ADDENDUM # 1

City of Sedalia Project Number: 2024-009

Sedalia Small Sewer Project “A”

Sheet
C1.01

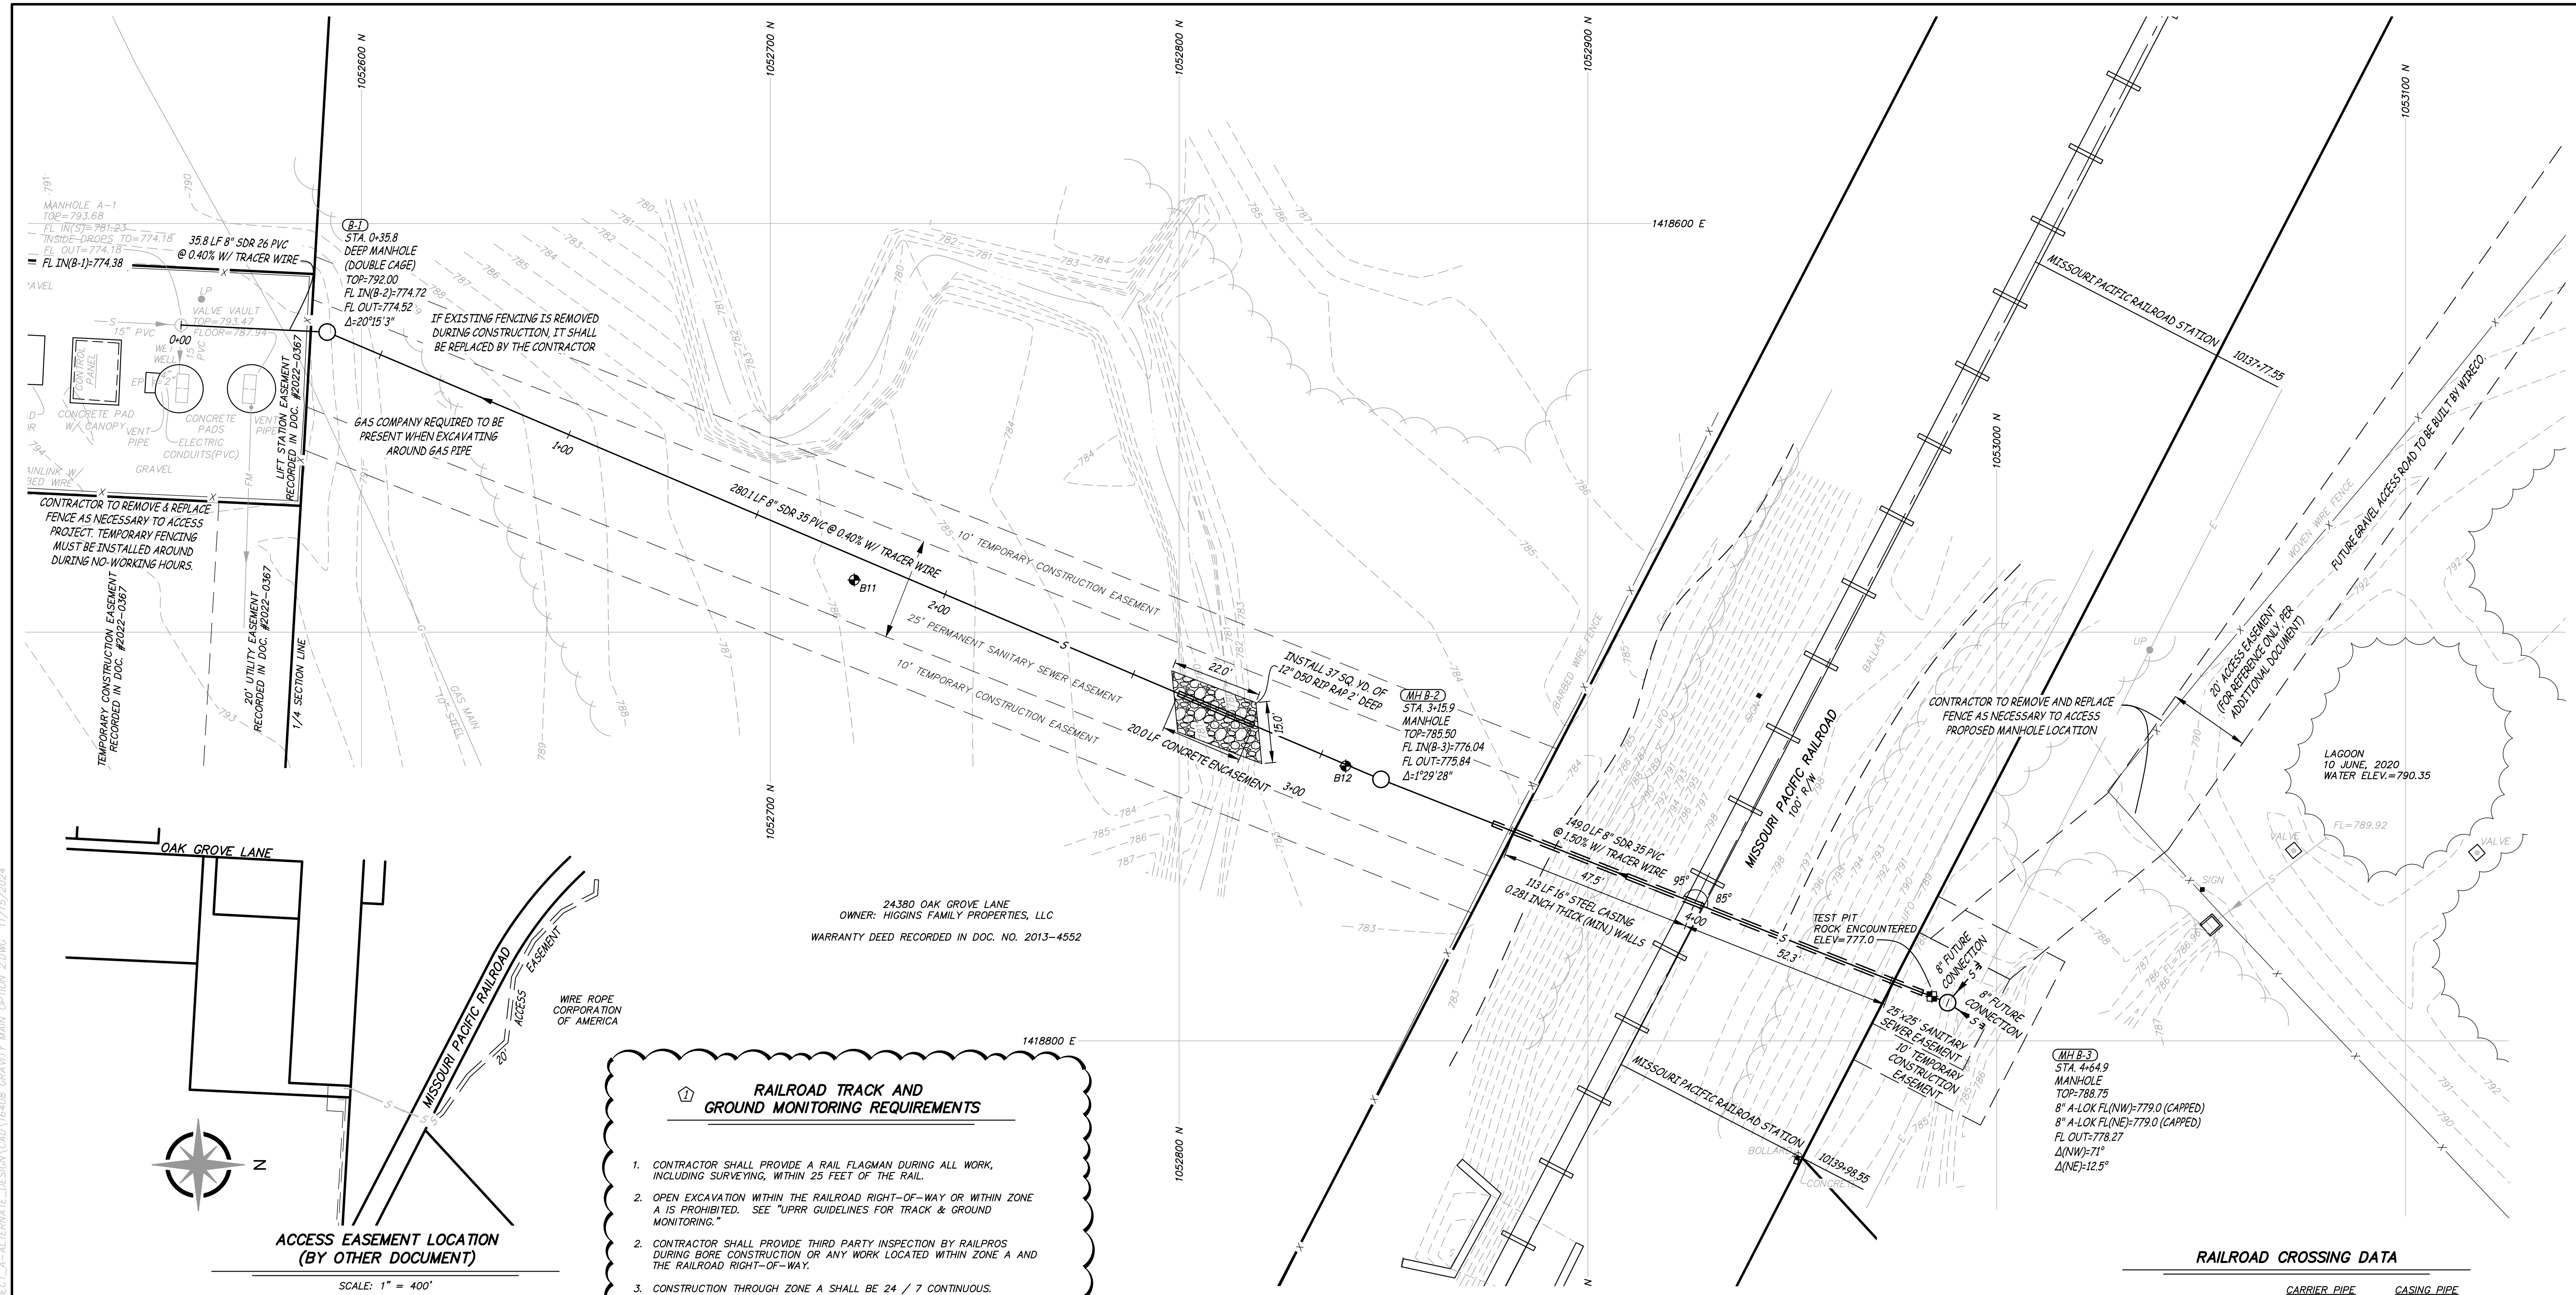
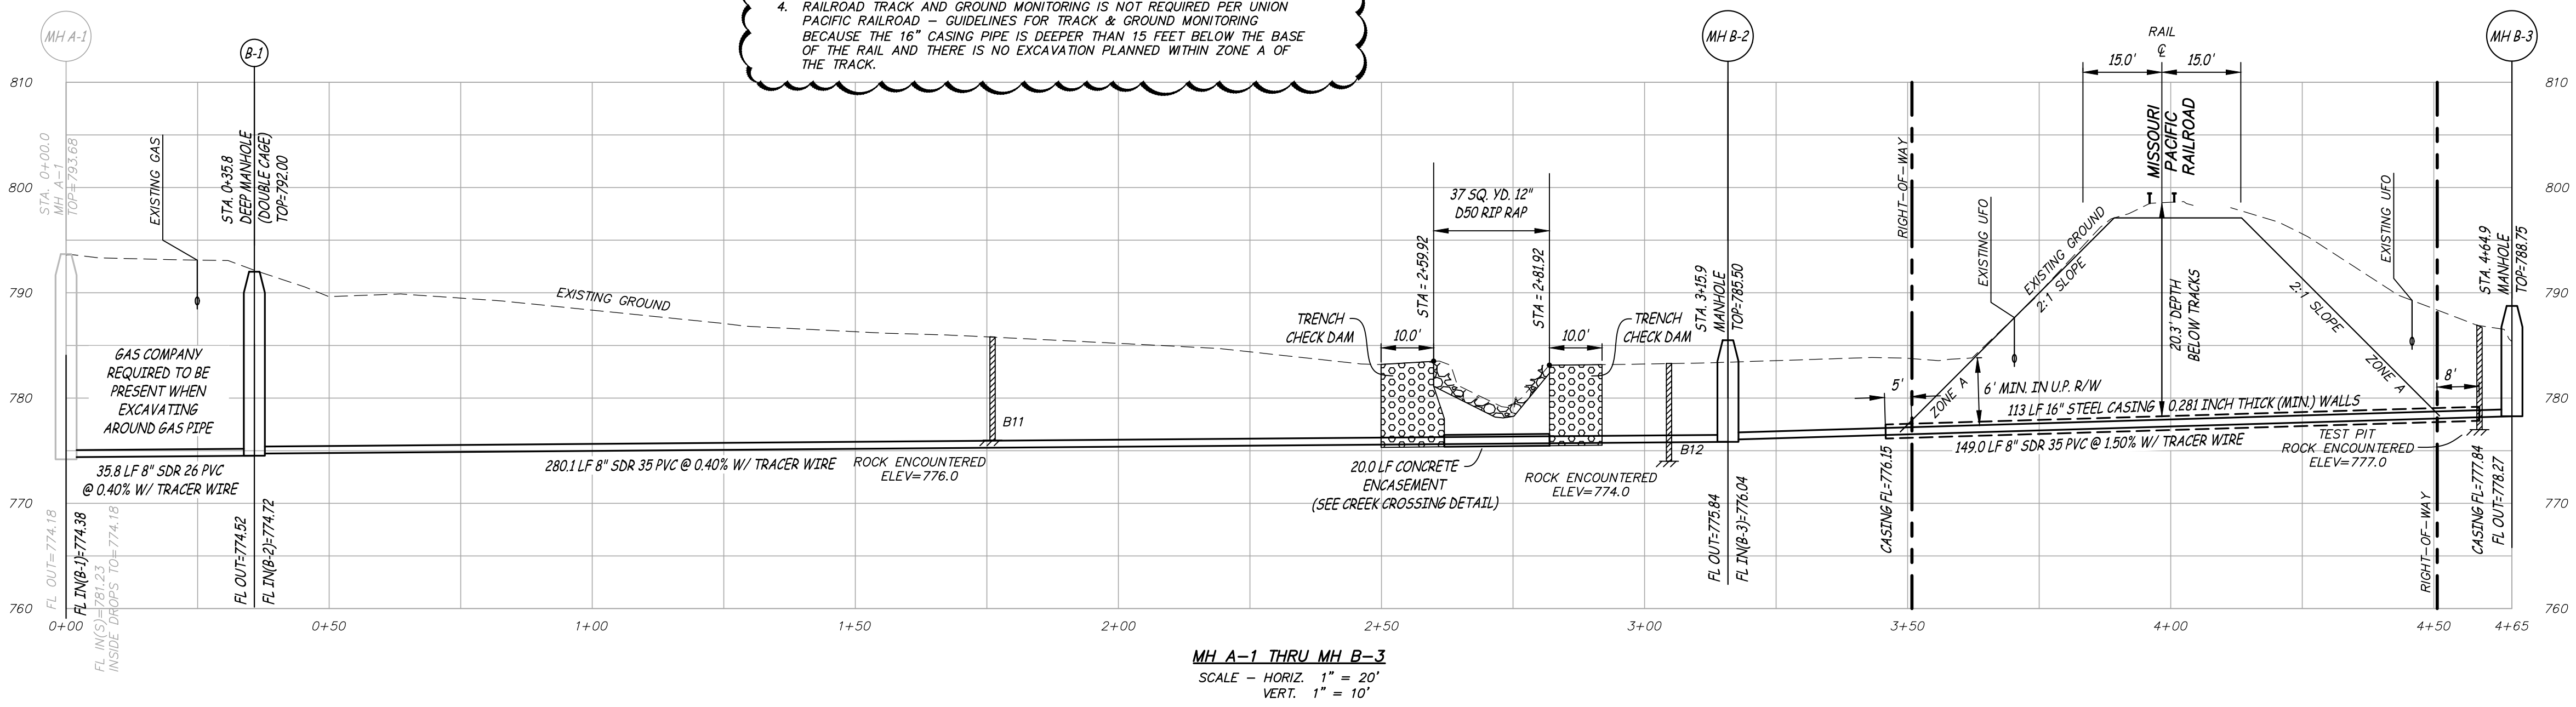
Option #2 Plan Set – sheet C1.01 was revised to add RailPros Construction Observation & Flagging requirements as well as 24/7 continuous construction notes for the bore under Union Pacific Railroad. The revised sheet is included with this Addendum #1.

- CONTRACTOR SHALL PROVIDE A RAIL FLAGMAN DURING ALL WORK, INCLUDING SURVEYING, WITHIN 25 FEET OF THE RAIL.
- OPEN EXCAVATION WITHIN THE RAILROAD RIGHT-OF-WAY OR WITHIN ZONE A IS PROHIBITED. SEE "UPRR GUIDELINES FOR TRACK & GROUND MONITORING."
- CONTRACTOR SHALL PROVIDE THIRD PARTY INSPECTION BY RAILPROS DURING BORE CONSTRUCTION OR ANY WORK LOCATED WITHIN ZONE A AND THE RAILROAD RIGHT-OF-WAY.
- CONSTRUCTION THROUGH ZONE A SHALL BE 24 / 7 CONTINUOUS.
